SECTION 00 91 10

ADDENDUM NUMBER 1

- 1.01 DATE: MAY 14, 2018**
- 1.02 PROJECT: AUSTIN HIGH SCHOOL CAREER TECH CENTER**
- 1.03 PROJECT NUMBER: B. C. NO. 2018112**
- 1.04 OWNER: DECATUR CITY SCHOOLS**
- 1.05 ARCHITECT: NOLA | VAN PEURSEM ARCHITECTS, PC**

CULINARY SPA, 131
COLD WATER DIAGRAM
NOT TO SCALE

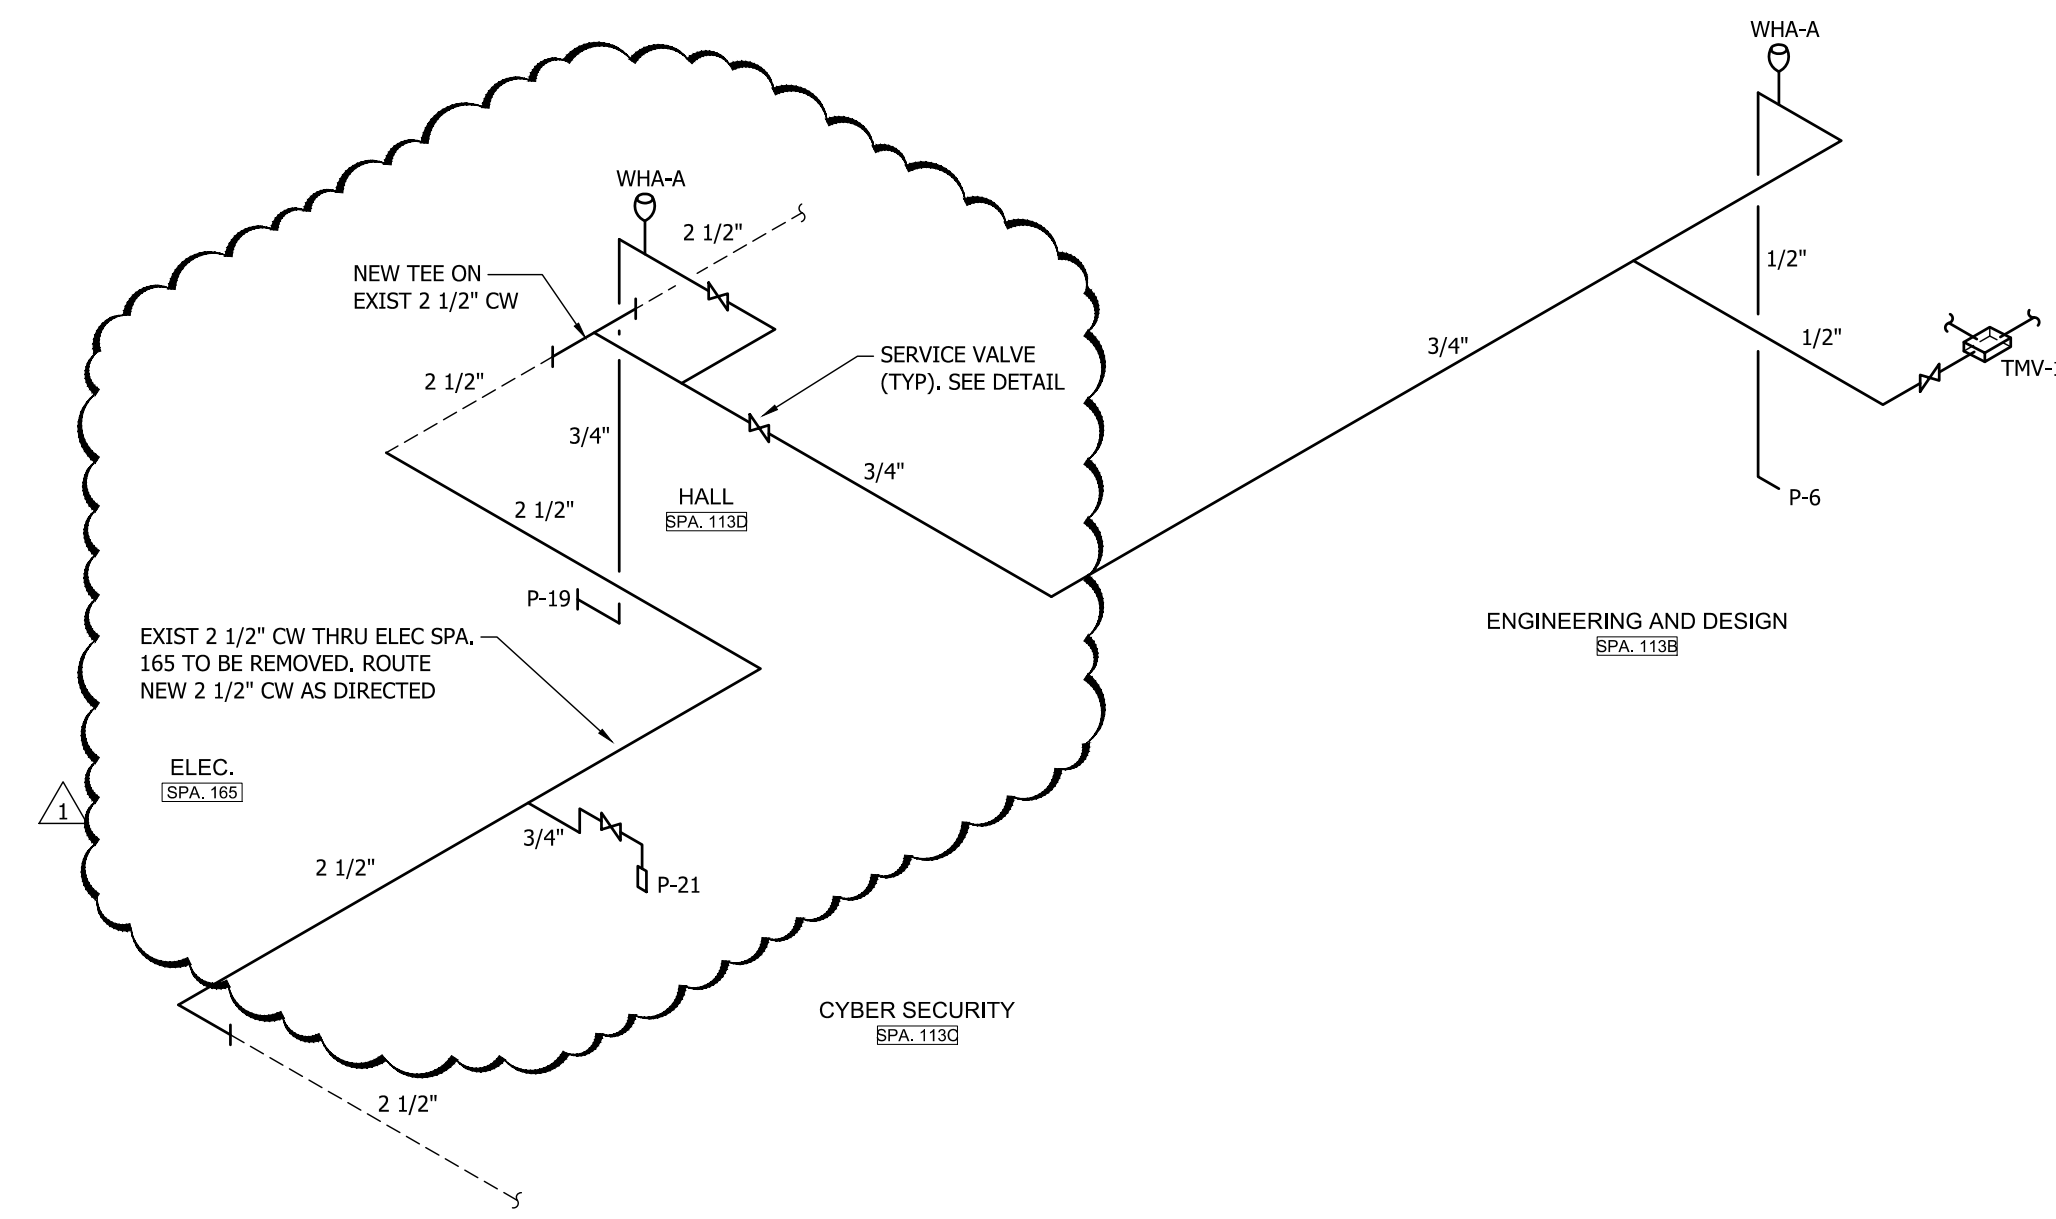
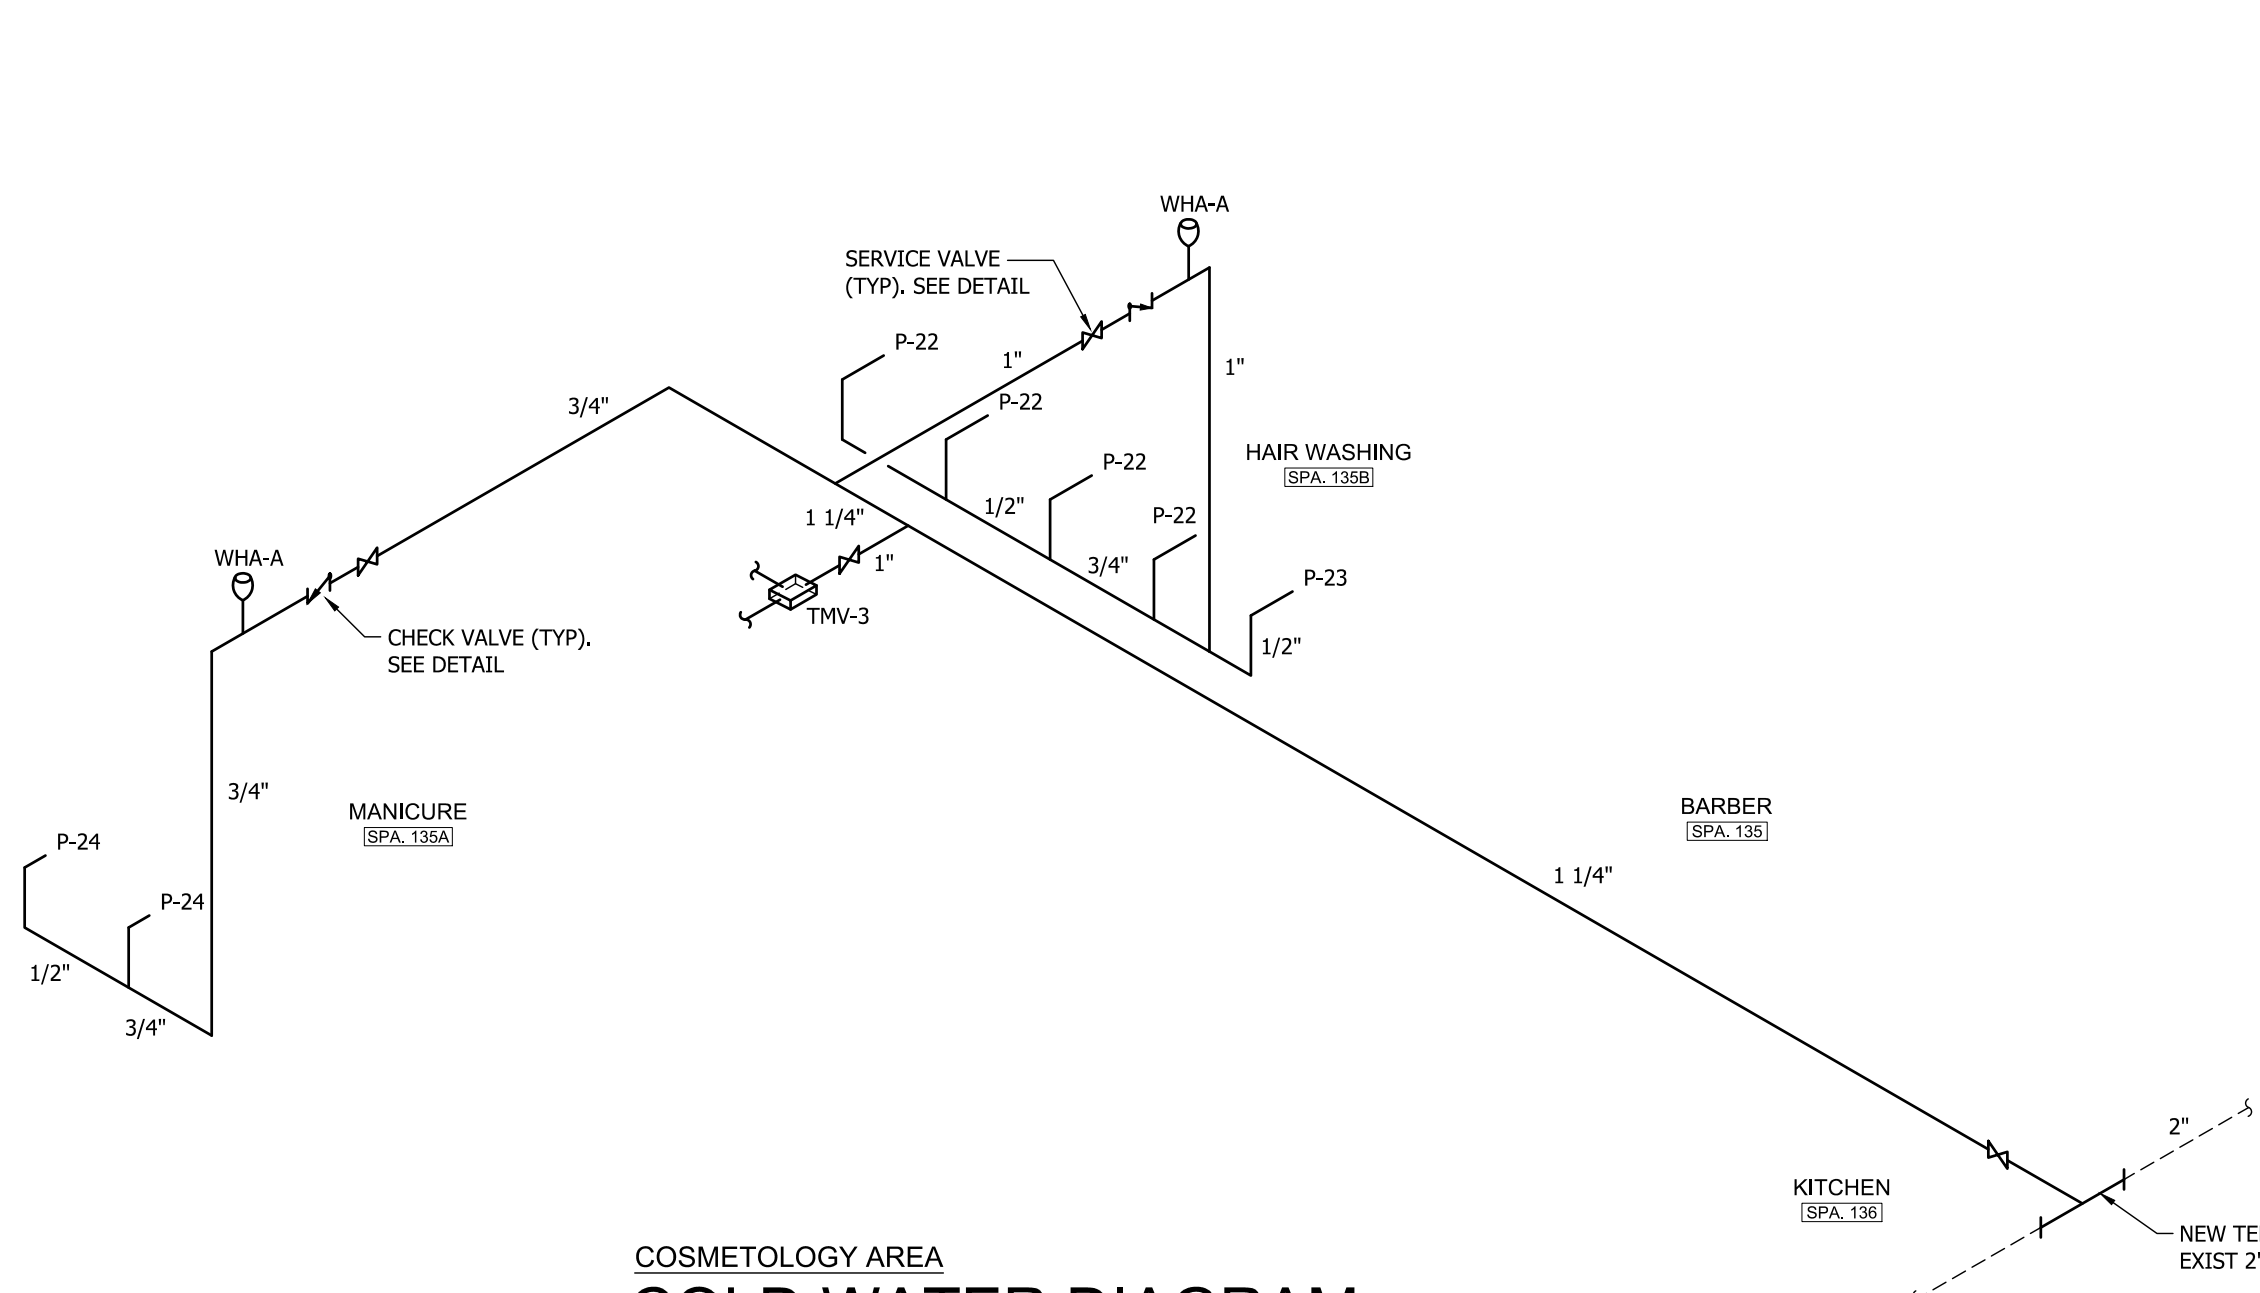
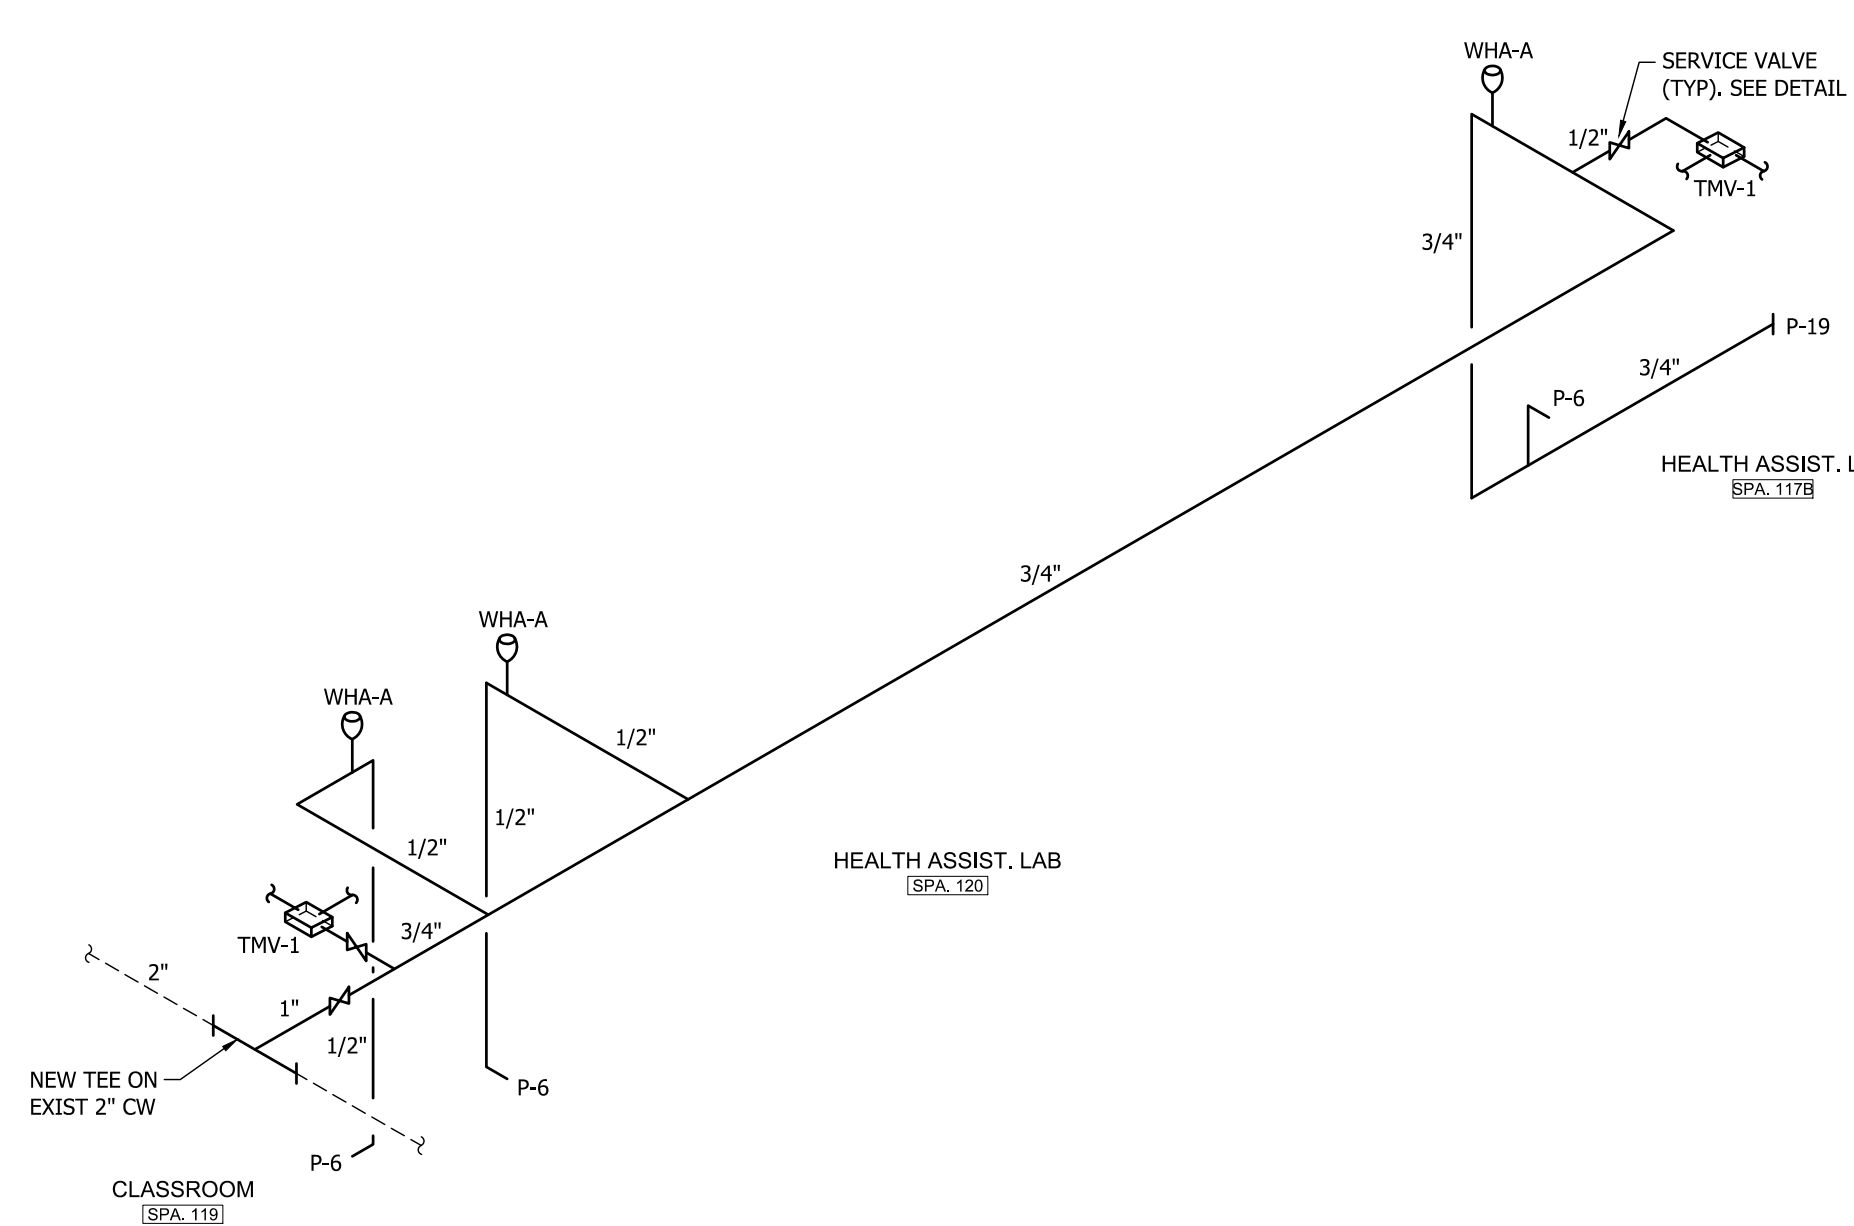
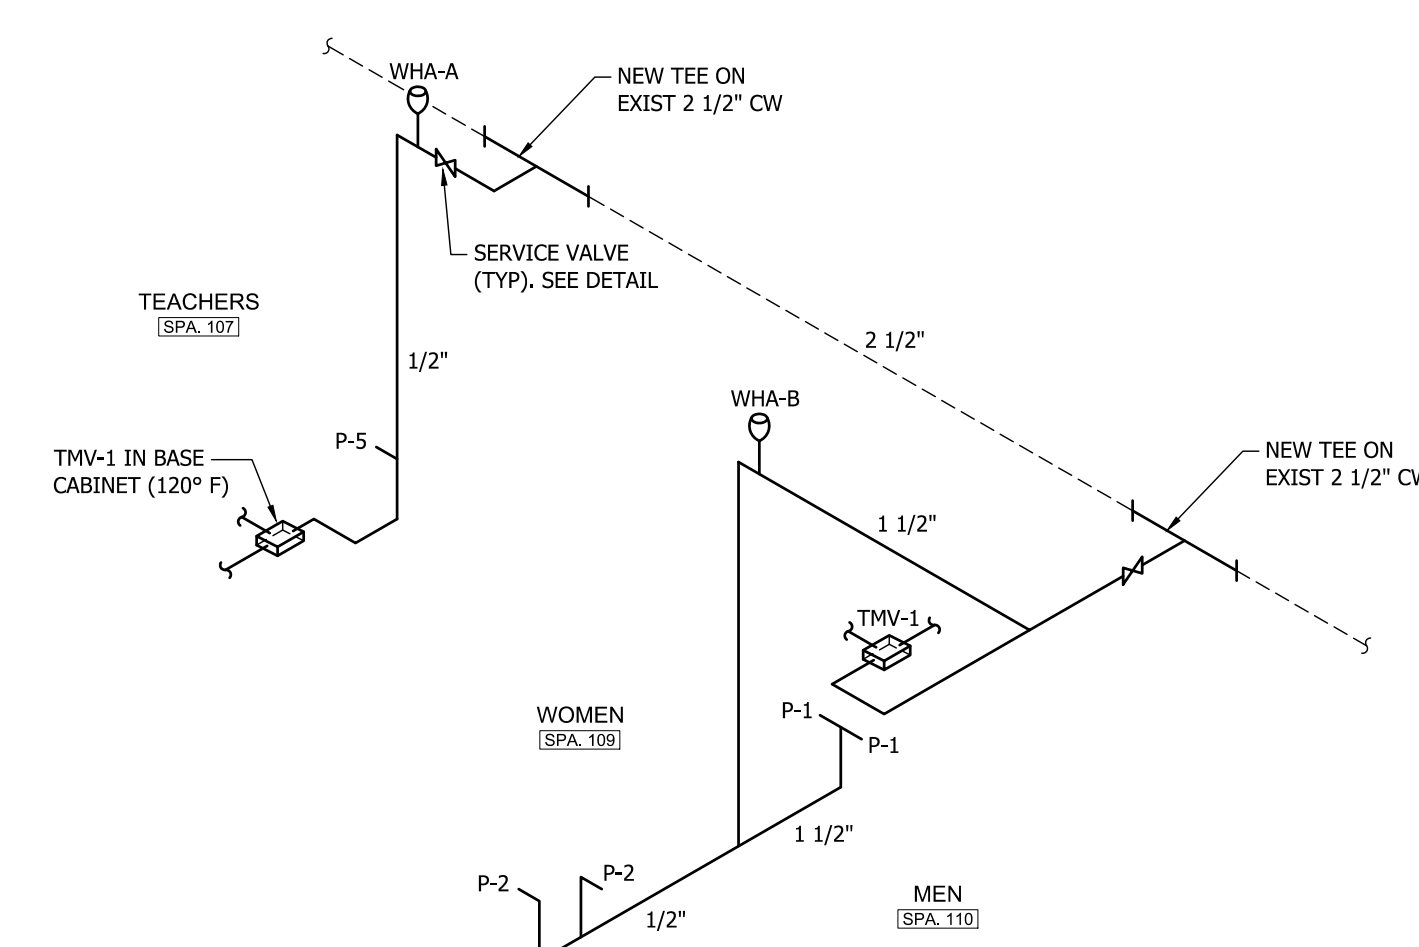
- A. Replace this sheet in its entirety, the list of changes are as follows:
1. The P-19 Exterior Wall Hydrant on the south wall has been moved. The Cold Water Diagram has been changed to match the change on the floor plan.
